**WAITROSE
RECTORY ROAD
WOKINGHAM**

**CONDITION SUMMARY AND WORKS
REQUIRED TO WALL H1**

JOHN LEWIS PARTNERSHIP

HURST PEIRCE + MALCOLM LLP

Wall H1 at the Waitrose Store End

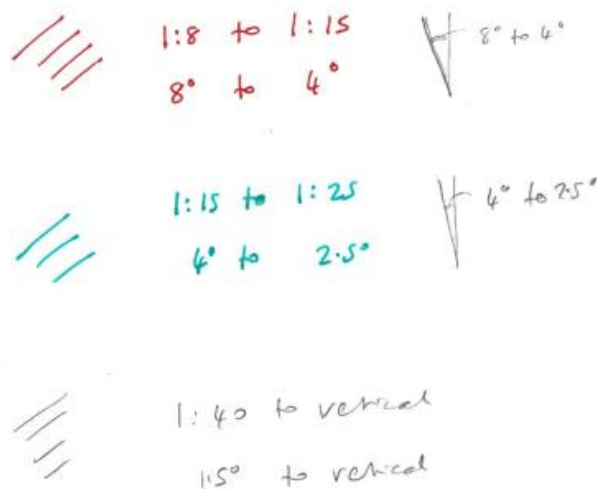
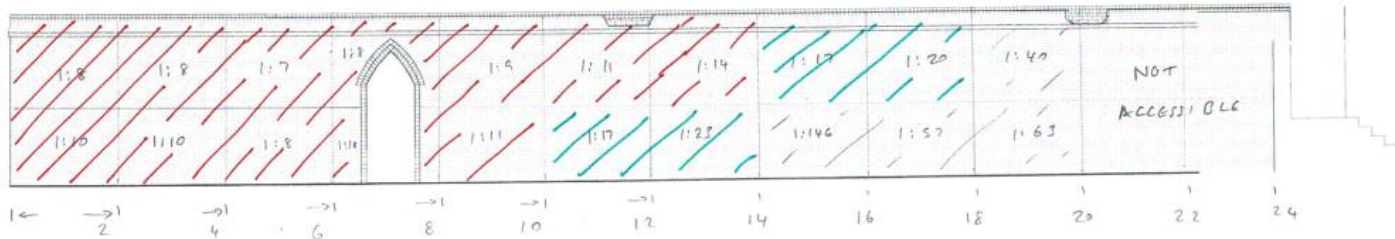
- 3.1 Wall H1 is 3.5m tall, 325mm thick and out of plumb by 260mm at the store end. This is equivalent to 1:10. It is pushing over an adjacent concrete fence post which may be providing support. The centre of gravity of the wall over the end 14m is well outside the middle third so the wall is unstable and at risk of collapse.
- 3.2 The wall would collapse on to the neighbouring car park and would cause serious injury if it landed on anyone. Additionally, if the fence post gave way, the end of the wall would collapse and is likely to pull the remainder of the wall down with it. Waitrose have cordoned off the affected car parking spaces on both sides of the wall.

- 3.3 The wall is out of plumb for all of its 25m length but the 14m closest to the Waitrose Store is leaning the most and the lean at the store end has increased by approximately 10mm over the past year.

- 3.4 An inclinometer survey was carried out by HPM on 04.04.24 and the results shown below confirm that the lean of the end 14m is between 4° and 8° (or 1:8 to 1:15). The maximum lean for the wall to comply with building regulations and be considered stable is 1° or 1:57.

- 3.4 The lean is within the walls and not likely to be caused by foundation settlement or rotation. The BGS website shows the ground conditions to be alluvial deposits overlying sand (Bagshot formation).
- 3.5 There is an archway at approximately 7m from the store end where the lean of the wall is severe. This arch is bricked up with a rough, $\frac{1}{2}$ brick thick, panel that is not original and is not bonded to the arch.
- 3.6 Work required to wall H1 is shown on HPM drawing "25317-01 P4 Proposed Elevations & Details Wall H1".
- 3.7 The extent of the works shown on Drawing 25317-01 rev P4 are taken from the Morton partnership letter report to Waitrose dated 23.05.24. These works were agreed on site between Waitrose and the planners. HPM are not taking design responsibility for this work as agreed by Waitrose June 2024.
